NIDEC MOTOR CORPORATION 09-Feb-16

REVISION RECORD FOR: ECO: E24810

TITLE	CODE	ITEM NO.	REV	SHEET NUMBER	DWG SIZE
CUSTOMER DETAIL DRAWING	V02	803552	E	1 OF 4	B

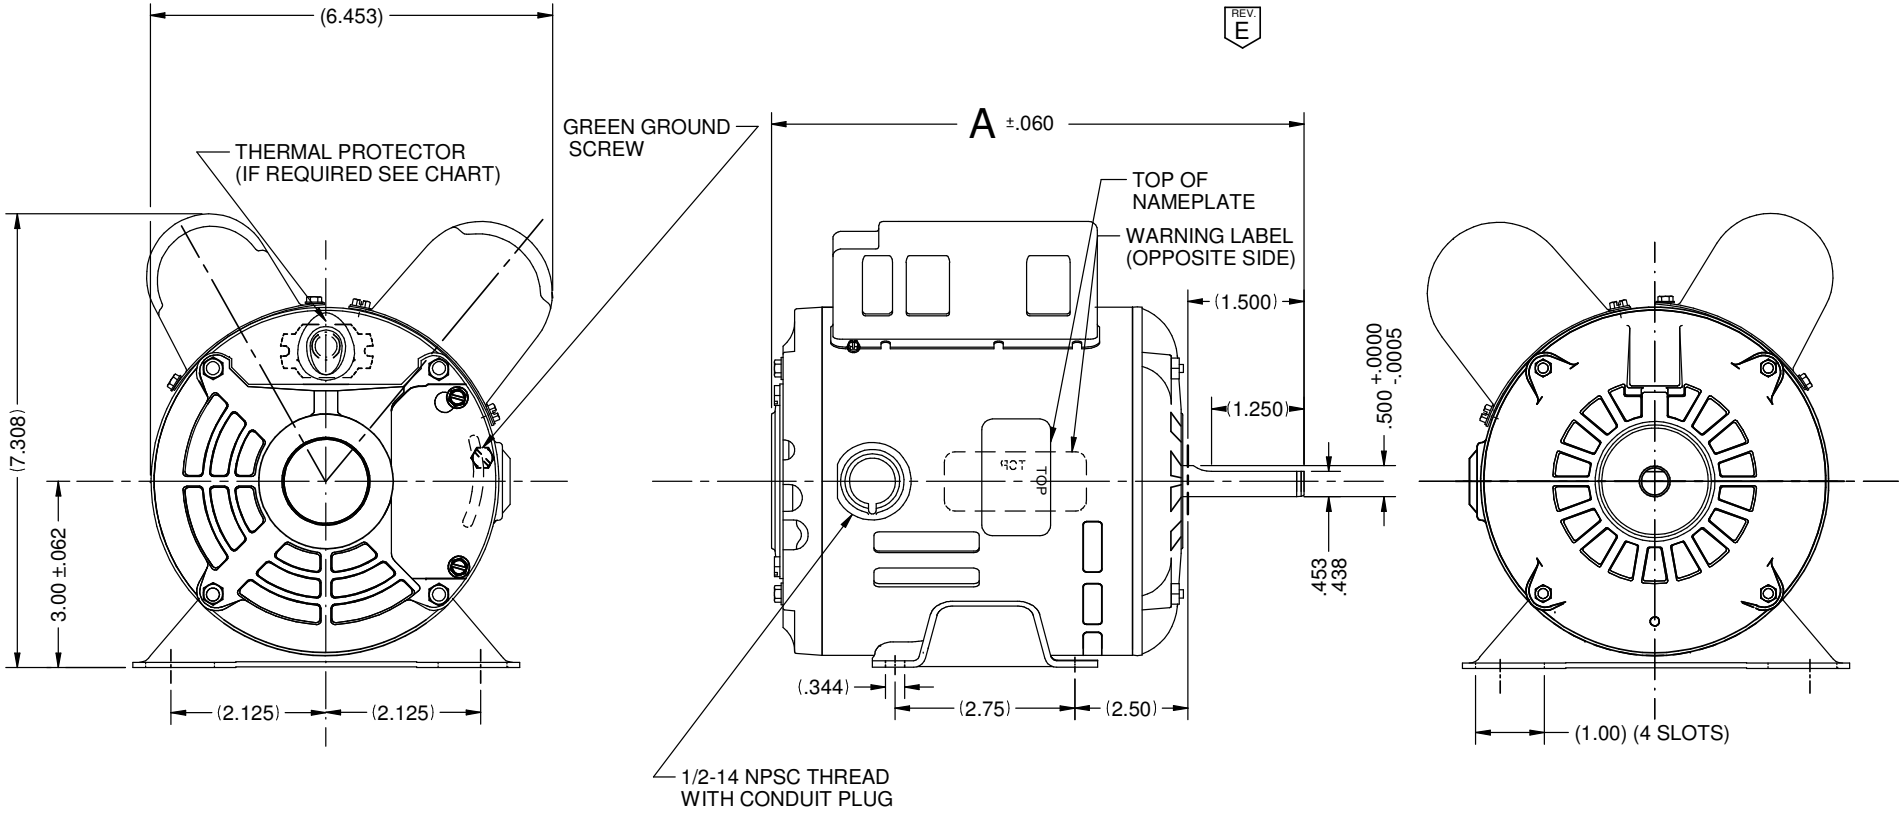
CHANGE AMPERES IN VAR 001 AND 002 FROM "6.4/3.2" TO "5.0/2.6"
